DC30
Channel 1 & Channel 2 Preamps
9 Nov 2008. I. G. Morris

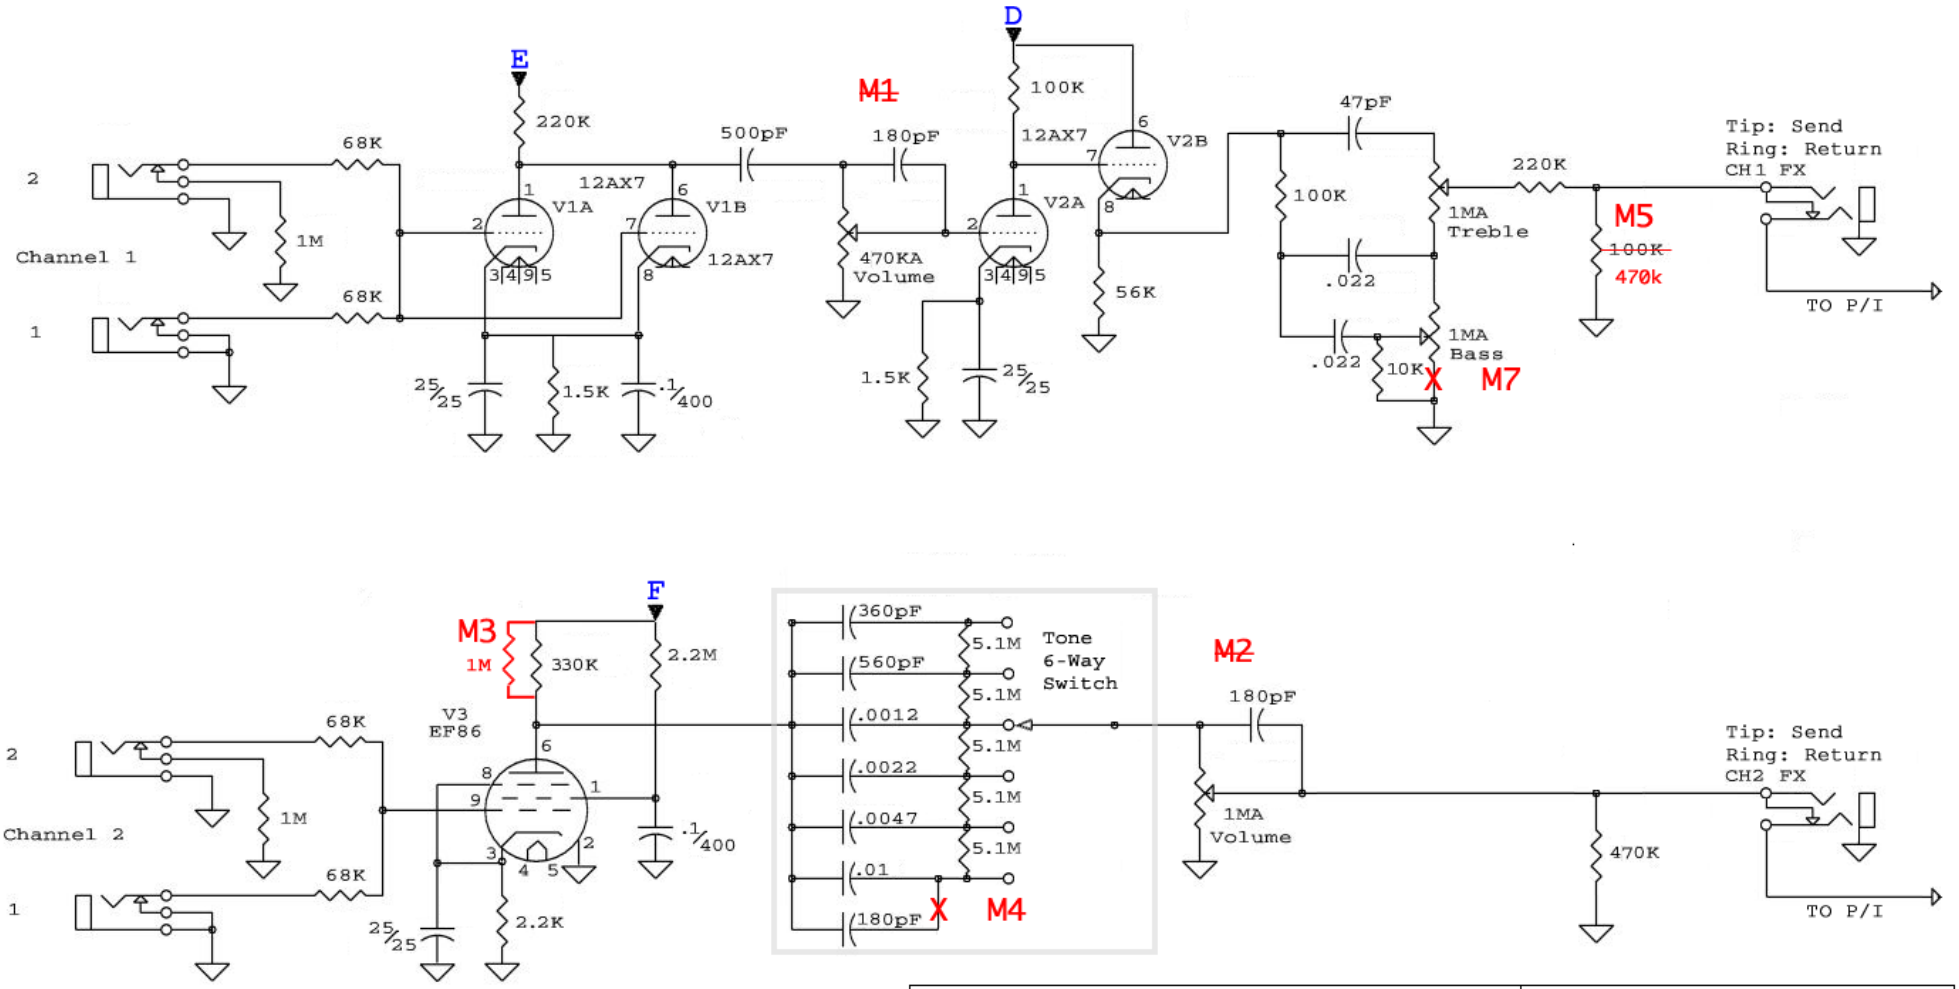
~~M1, M2: Bright caps disconnected.~~ ~~Reinstated, 27/10/09~~
M3: 1M added in parallel = approx 250K. 27/4/08
M4: 180pf removed when it went leaky. 16/7/08
M5: Replaced 100K to ground with 470K. 9/1108
M6: Replaced cabling to Ch1 insert with shielded cable as existing cable was microphonic. 9/11/08
M7: Disconnected bass pot from ground, 27/10/09
